To All Chrysler-Plymouth Dealers

Modification of Brake Master Cylinder  
Auxiliary Reservoir Anchor Plate

Models Affected: 1965 and 1966 Chrysler, Plymouth Fury, Valiant, and Barracuda equipped with disc brakes.

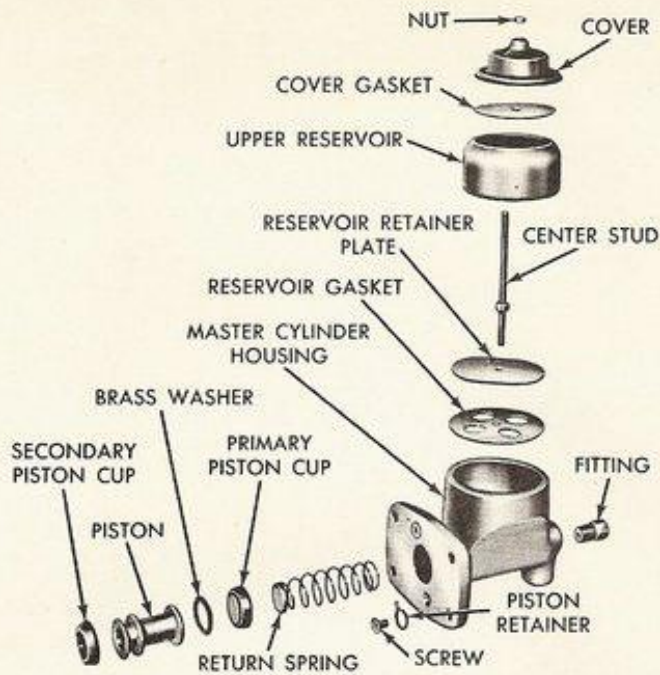
This change consists of a modification to the auxiliary reservoir anchor plate by drilling three (3) holes 3/16" diameter, equally spaced, as shown in the following sketch. This change entered production approximately January 31, 1966. Cars equipped with the drilled anchor plate can be identified by a daub of white paint on the auxiliary reservoir. To help identify the reworked units in the future, it is suggested that you place a white daub of paint on the auxiliary reservoir of each master cylinder that you modify.

1. Clean all dirt from master cylinder cover and remove same.
2. Using a clean suction gun, remove the brake fluid from the auxiliary reservoir only.
3. Remove the auxiliary reservoir attaching screw, anchor plate and reservoir.
4. Using the enclosed diagram as a template, lay out and drill three (3) holes, 3/16" in diameter, in the anchor plate.
5. Deburr and remove all loose particles before reinstalling plate and master cylinder reservoir.
6. Reassemble reservoir, anchor plate and attaching screw. Be sure to align upper reservoir on the master cylinder casting. Tighten retaining screw to 50 inch pounds.
7. Refill reservoir with clean brake fluid. Install cover on reservoir and check brakes for proper operation.

Disc Brake Master Cylinder (Exploded View)

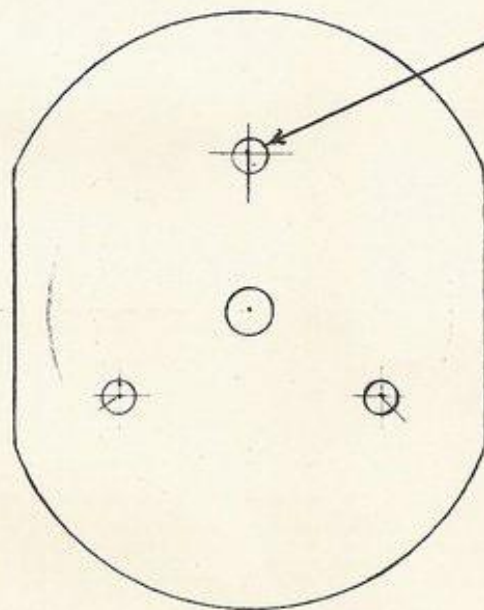
DRILL 3 HOLES 3/16" DIA.  
EQUALLY SPACED AS SHOWN.  
DEBURR AND REMOVE ALL  
LOOSE PARTICLES BEFORE  
INSTALLING IN MASTER  
CYLINDER RESERVOIR.
